# NEWMAR CORPORATION WARRANTY DEPARTMENT

TECHNICAL SERVICE BULLETIN													
DATE ISSUED		MODEL YEAR(S) AFFECTED			MODEL(S) AFFECTED			TSB #					
5/27/99		1999			CLASS A'S			173					
BRAND					TYPE								
All	<input type="checkbox"/>	American Star	<input type="checkbox"/>	Kountry Star	<input checked="" type="checkbox"/>	Dutch Star	<input checked="" type="checkbox"/>	All	<input type="checkbox"/>	T T	<input type="checkbox"/>	F W	<input type="checkbox"/>
NewAire	<input type="checkbox"/>	Mountain Aire	<input checked="" type="checkbox"/>	Kountry Aire	<input type="checkbox"/>	London Aire	<input type="checkbox"/>	C A	<input checked="" type="checkbox"/>	D P	<input type="checkbox"/>	D B	<input type="checkbox"/>
<input type="checkbox"/> Air Conditioning & Heating					<input type="checkbox"/> Electrical Components								
<input type="checkbox"/> Appliances & Accessories					<input type="checkbox"/> Exterior Components								
<input type="checkbox"/> Cabinets & Furniture					<input type="checkbox"/> Interior Components

### **F-53 FORD CHASSIS TECHNICAL BULLETIN PARTS LIST**

<b>NEWMAR CORP</b> P.O. Box 80, Nappanee, IN 46550 Title block--1-2/08	Model: <b>F-53 CHASSIS</b>	Sheet <b>1 OF

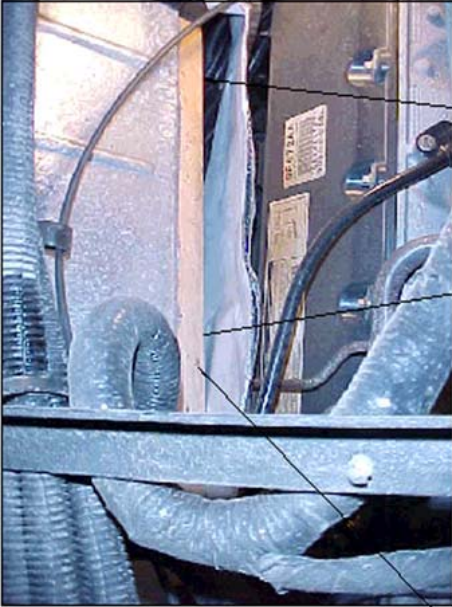
- 7.) With material making good contact throughout take 5/8" washer head screw (#11870) with an 1 1/2" washer (#18851) and attach near top corners through the Heat Shield.(see illustration)

- 8.) From underneath engine location, install a set of the screws and washers in each corner on the small radius side through Heat Shield. (see illustration)

Model:	F-53 CHASSIS	Sheet	3 OF 6	Drawn by:	STEVE M	Checked by:	Revisions:	By:	Date:
Title:	HEAT SHIELD ASSEMBLY	ID:	MISC\9A	Date:	4/13/99	Date:	Revisions:	By:	Date:
Title block--1-2141TB

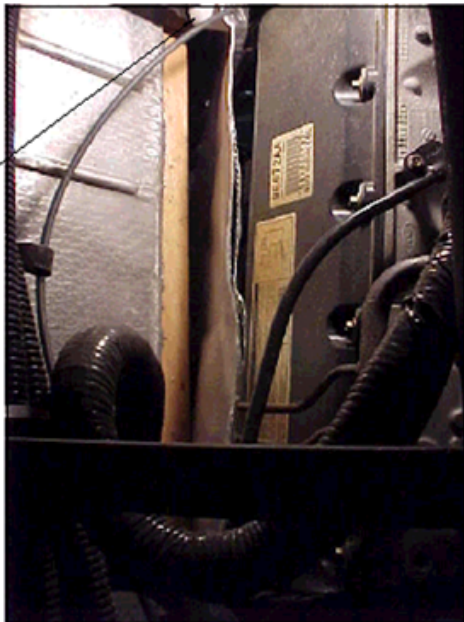
4) FROM INSIDE THE UNIT, SLIDE HEAT SHIELD INTO PLACE. NOTE THAT THE START POINT IS 1" PAST THE PEDAL PLATE ON THE DOG HOUSE PERIMETER. IT IS IMPORTANT THAT THE HEAT SHIELD IS FORMED NEATLY BETWEEN THE FIRE WALL AND EMISSIONS PIPE LOCATED NEAR THE REPAIR AREA.

<b>NEWMAR CORP</b> P.O. Box 80, Nappanee, IN 46550 Title block--1-2608	Model:	F-53 CHASSIS	Sheet	5 OF 6	Drawn by:	STEVE M	Checked by:	Revision:	By:
	Title	HEAT SHIELD ASSEMBLY	LO #	MJSL9\	Date:	4/13/99	Date:	Revision:	Date:

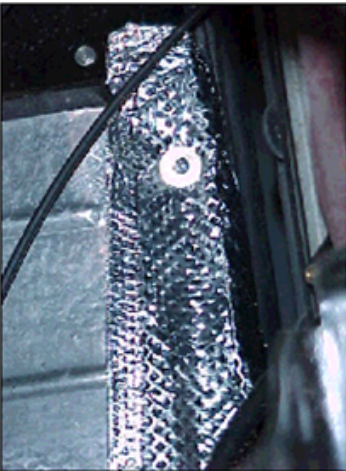
7) WITH MATERIAL MAKING GOOD CONTACT  
THROUGHOUT TAKE 5/8 WASHER HEAD SCREW  
(#11870) WITH AN 1 1/2 WASHER (#18851) AND  
ATTACH NEAR TOP CORNERS THROUGH THE HEAT  
SHIELD. <SEE ILLUSTRATION>

8) FROM UNDERNEATH ENGINE LOCATION,  
INSTALL A SET OF THE SCREW AND WASHER  
IN EACH CORNER ON THE SMALL RADIUS  
SIDE THROUGH HEAT SHIELD.  
<SEE ILLUSTRATION>
